Review of determination and stage 3 & 4 of the
East End Development at 121 Hunter Street
Newcastle

VISUAL IMPACT ASSESSMENT REVIEW

Prepared for: City of Newcastle

DOCUMENT CONTROL: Document no. 22224

P04 IMG 0025 : NEWCASTLE CLUB, WEST END MID-LEVEL (ADJACENT GROUND FLOOR) GARDEN TERRACE VIEW NORTH-NORTH-WEST
PHOTOMONTAGE - PROPOSED DEVELOPMENT

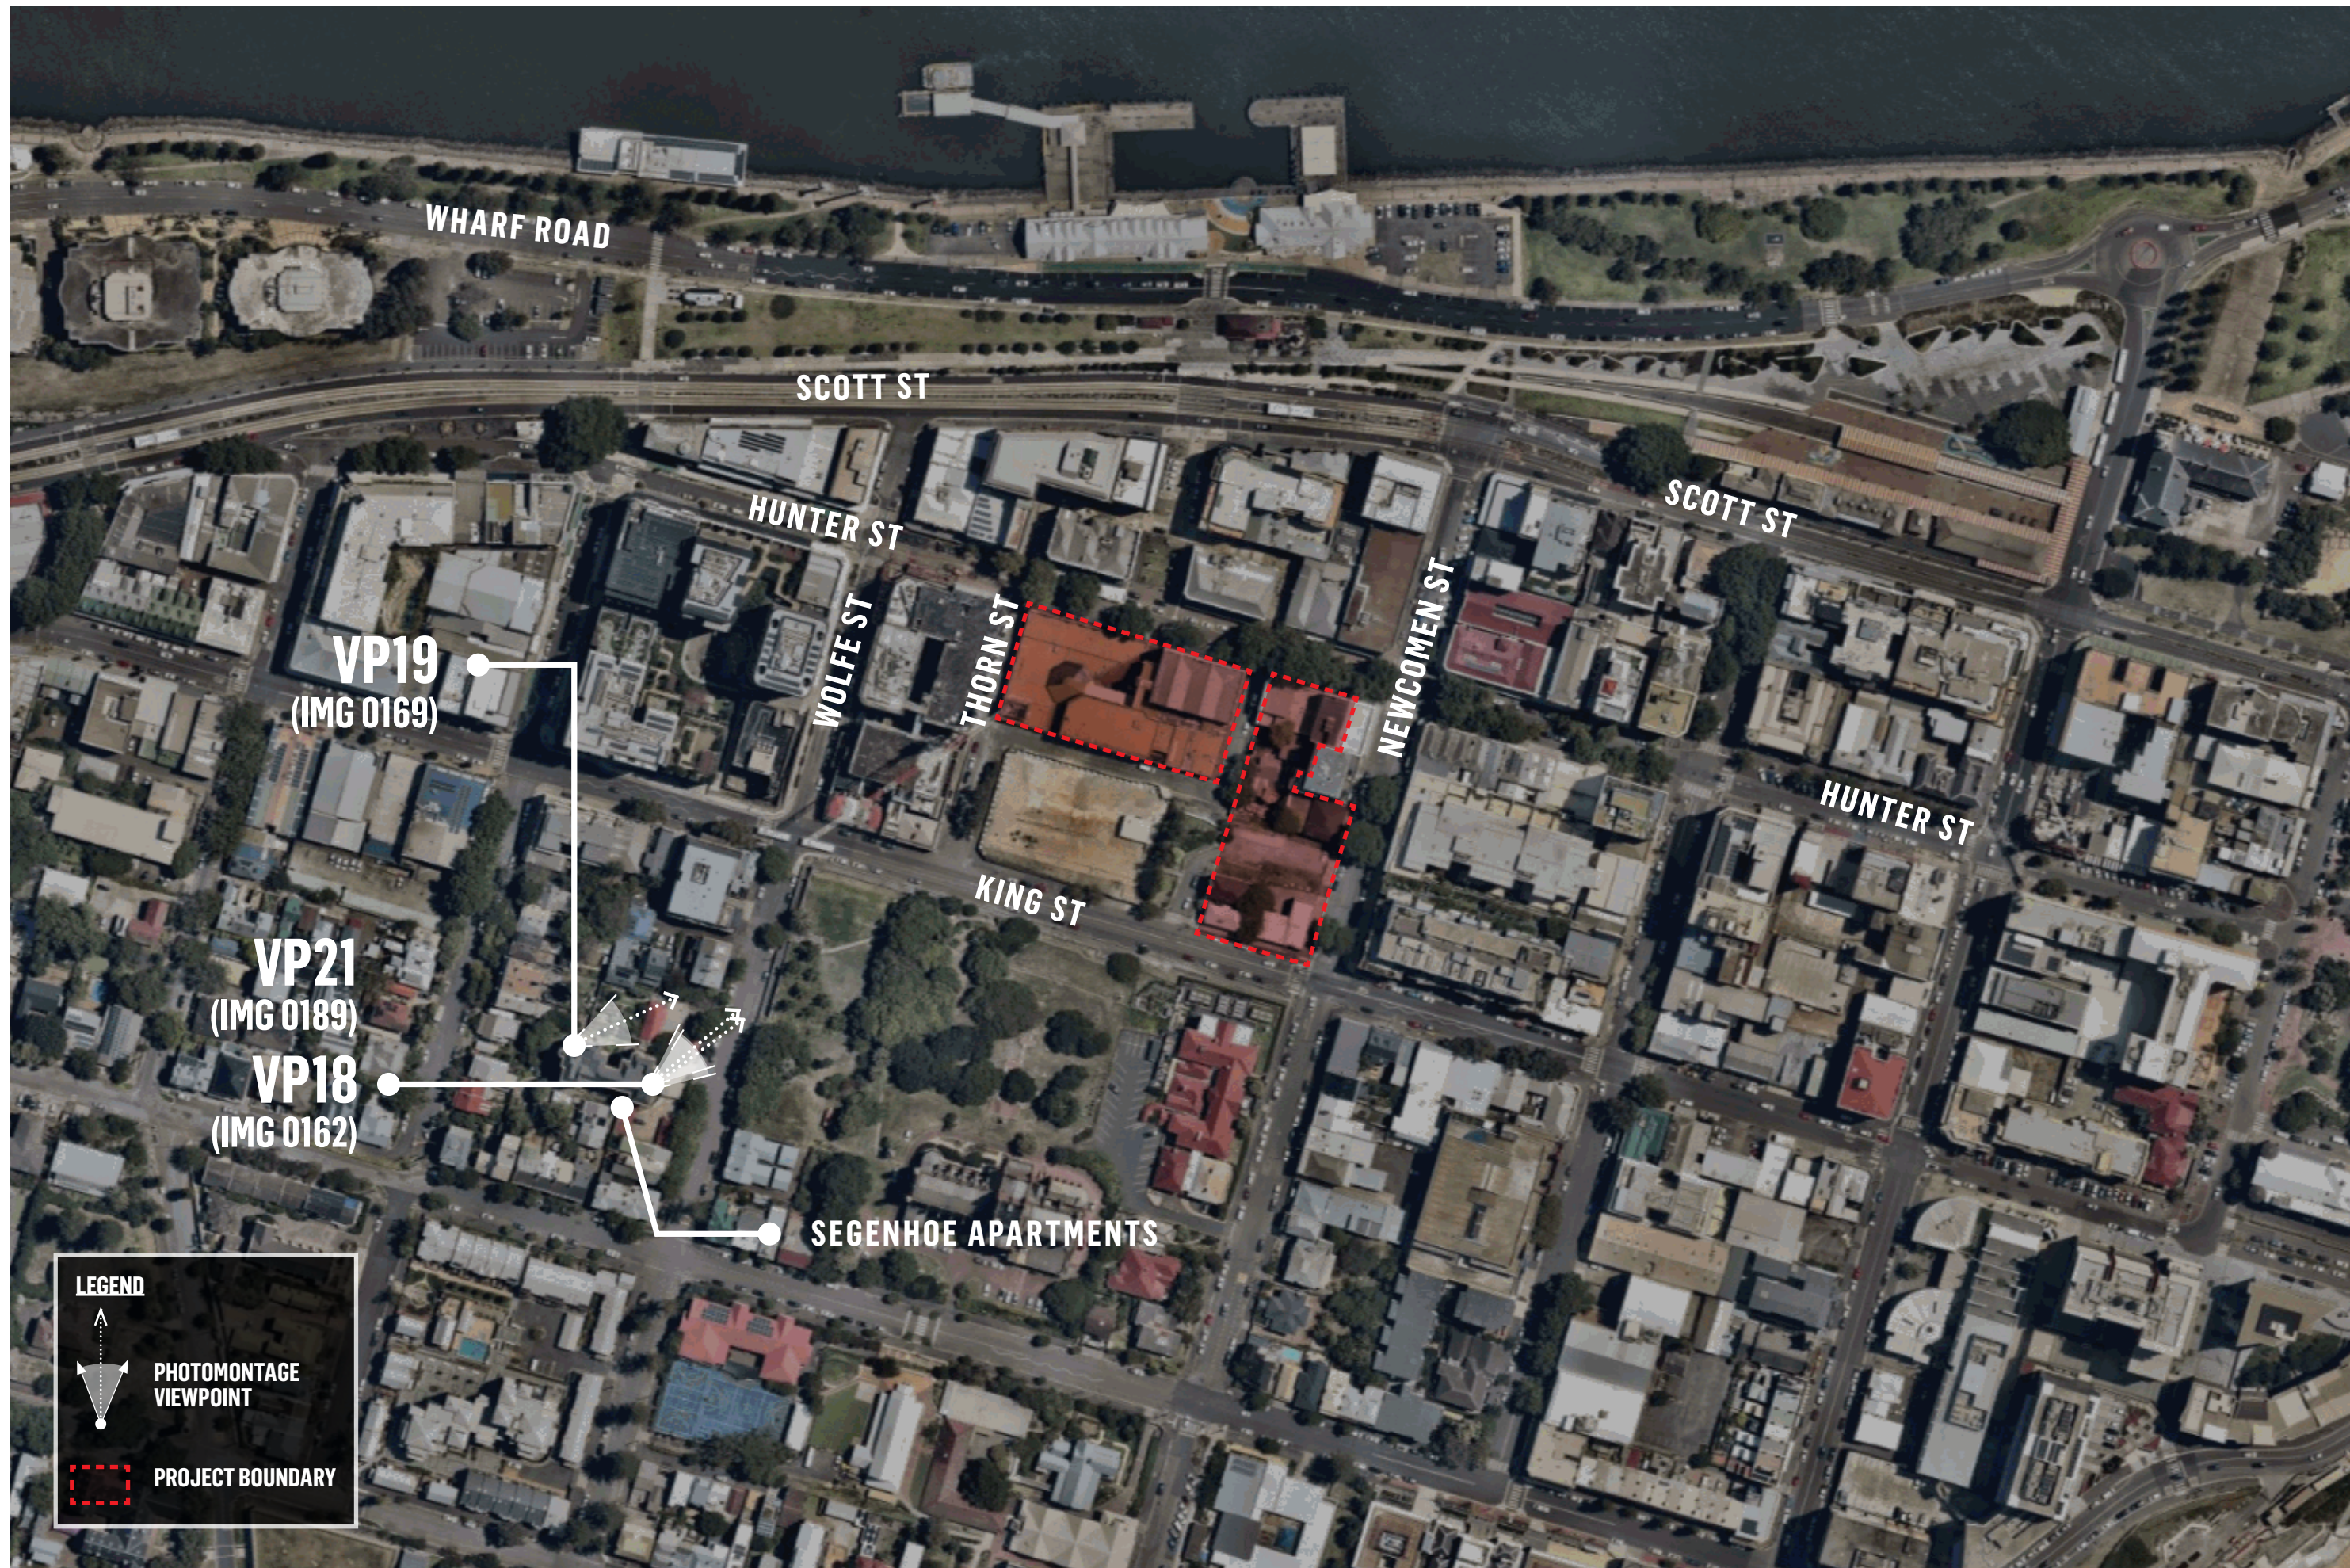
West end mid level garden terrace	Mid level	Yes	VP4 - does not show full view to E & 35mm focal length used	Moderate	Agree with impact rating, however, some assumptions made as entire	Neutral Little difference	Considerably negative Loss of some harbour views/Stockton due to upper storeys (rating reflects value of	Neutral Little difference (additional sky lost)	Neutral No change

VP19 IMG 0169 : SEGENHOE APARTMENTS, APARTMENT 20 STUDY AREA VIEW NORTH EAST
PHOTOMONTAGE - PROPOSED DEVELOPMENT

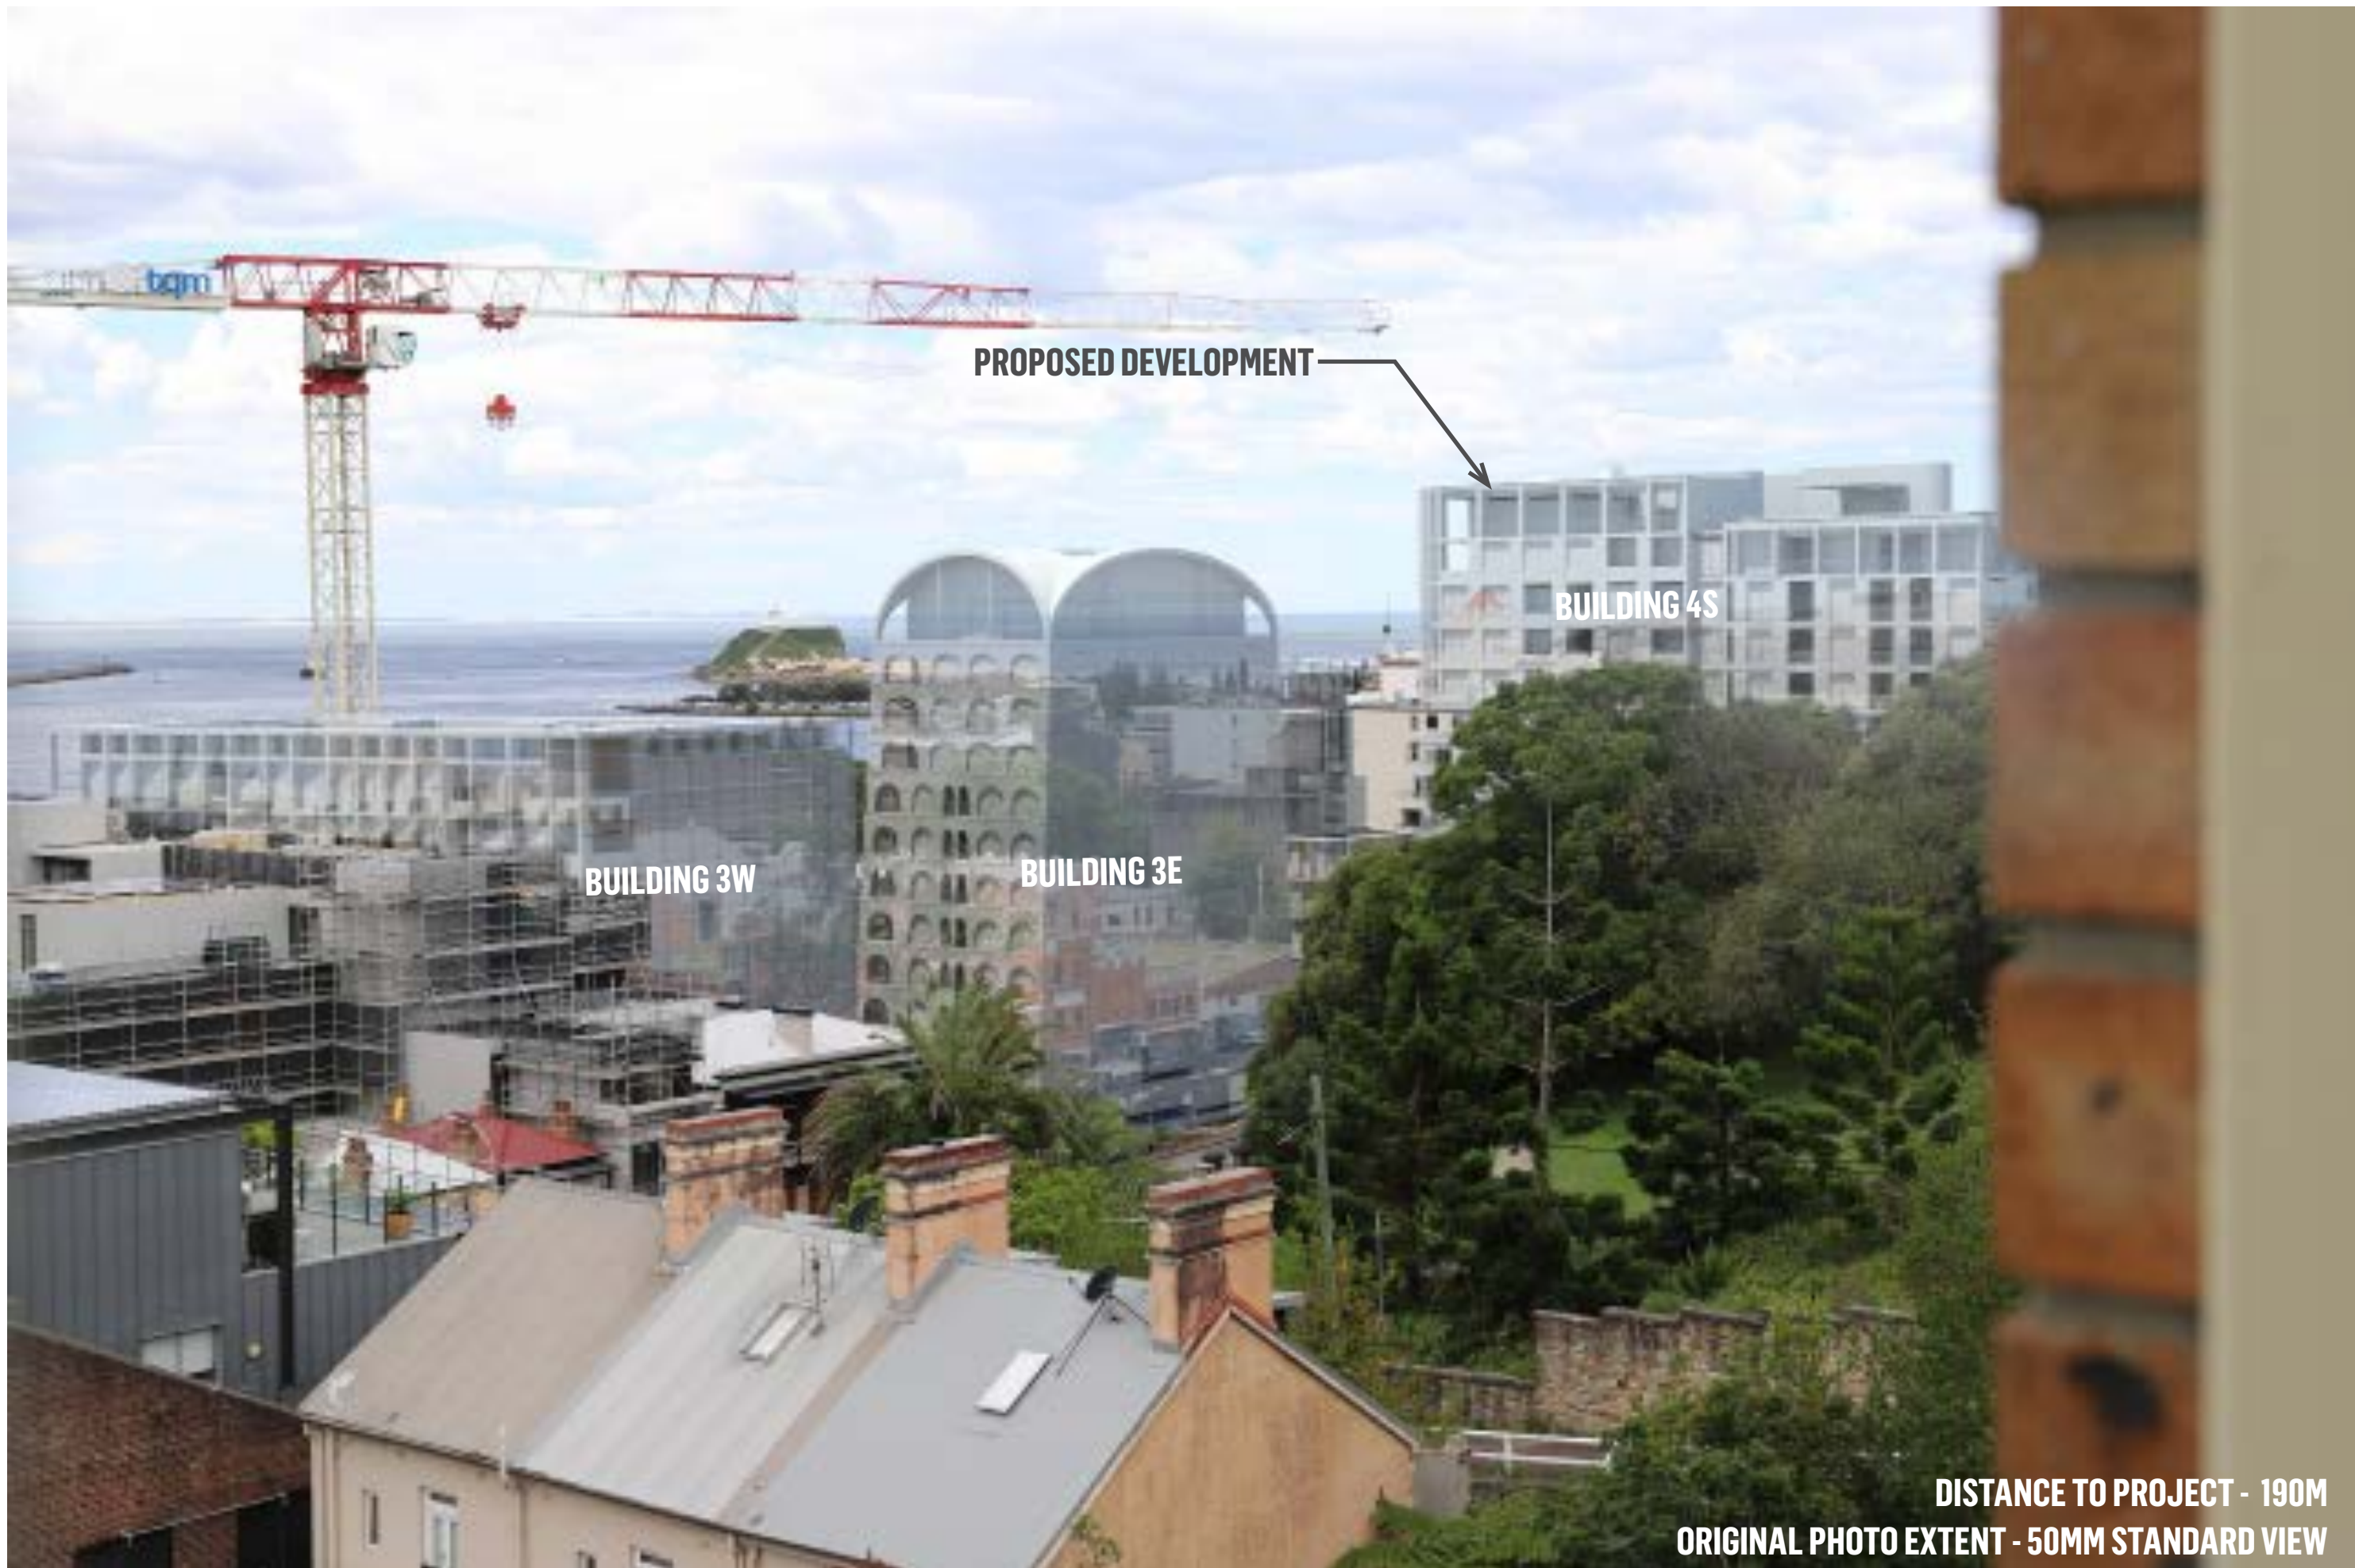
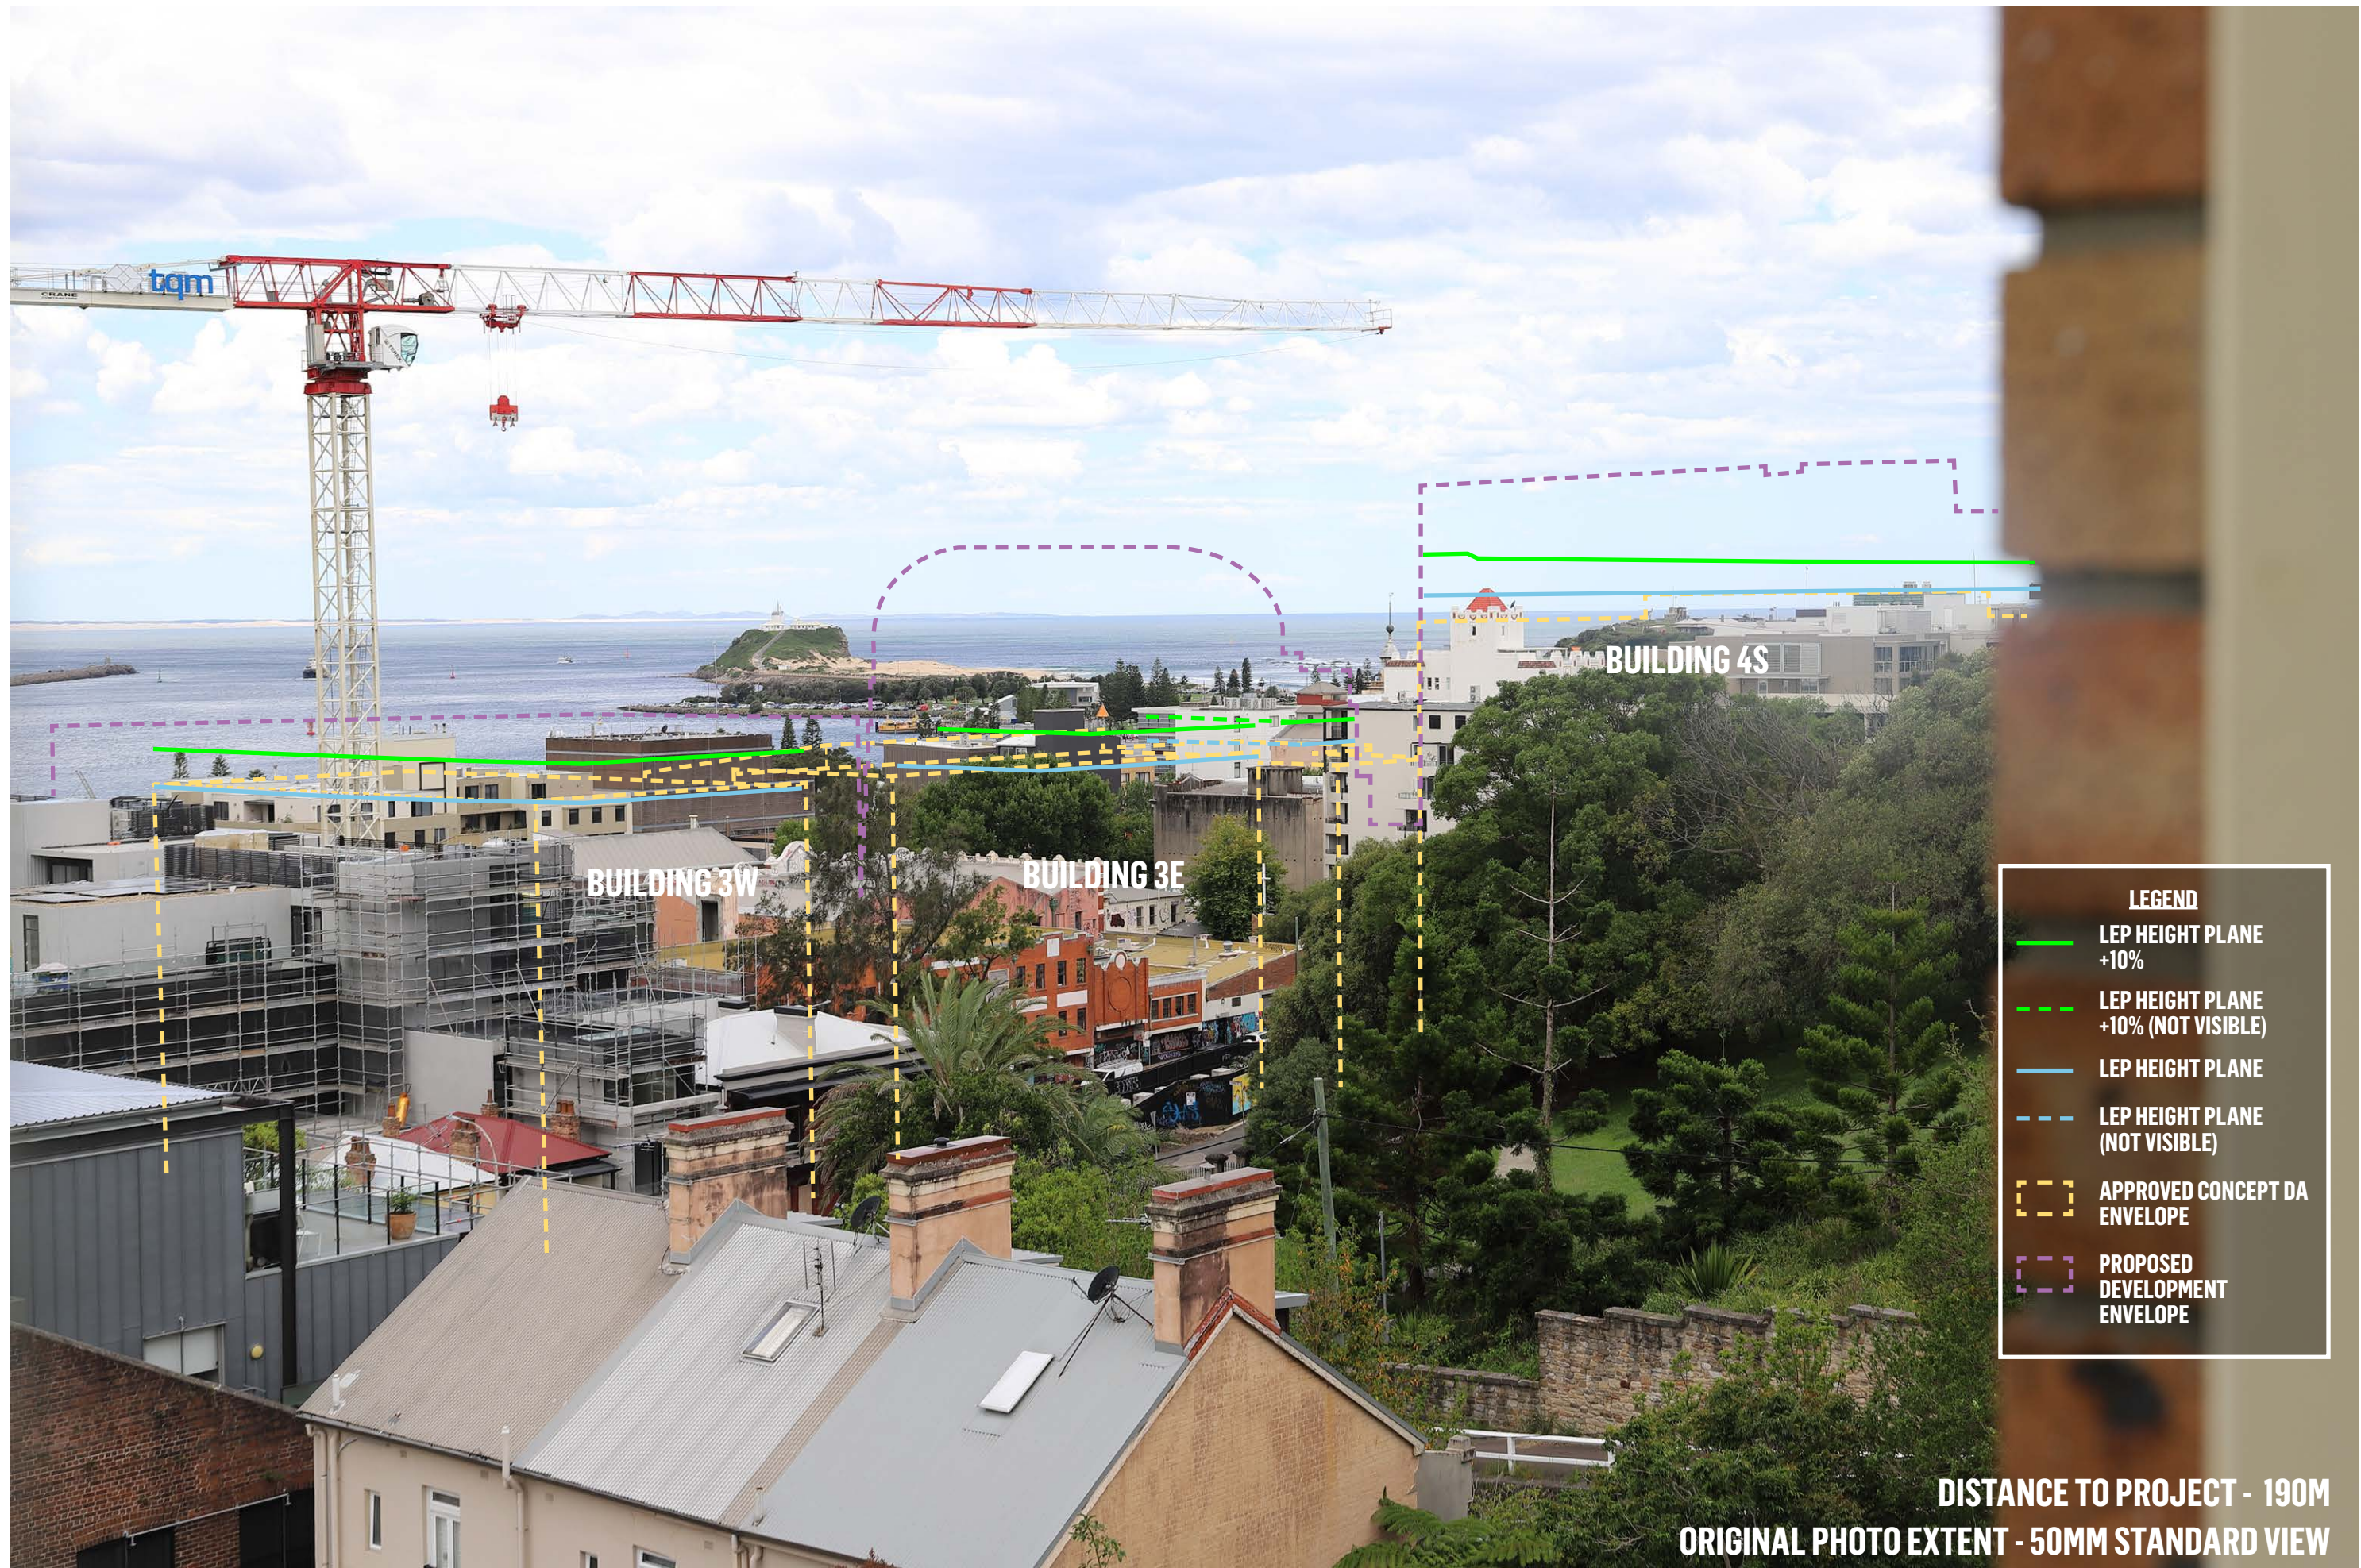
Segenhoe apartments (REFER PHOTOMONTAGES IN APPENDIX B)									
17	6 (strata plan floor 4)	No	Yes	Minor-moderate	Agree	Neutral Little difference	Considerably negative Upper storeys responsible for loss of entire Nobbys Headland view and break in ocean horizon	Neutral No change	Neutral Little difference
20	6 (strata plan floor 4)	Yes	Yes	Minor	Agree	Neutral Little difference	Partially negative Upper storeys responsible for loss of land connection to Nobbys Headland, and break in ocean horizon, however headland still seen view	Neutral No change	Neutral Little difference
21	7 (strata plan floor 5)	No	Yes	Minor-moderate	Agree	Neutral Little difference	Considerably negative Upper storeys responsible for loss of entire Nobbys Headland view and break in ocean horizon	Neutral No change	Neutral Some loss of ocean horizon however
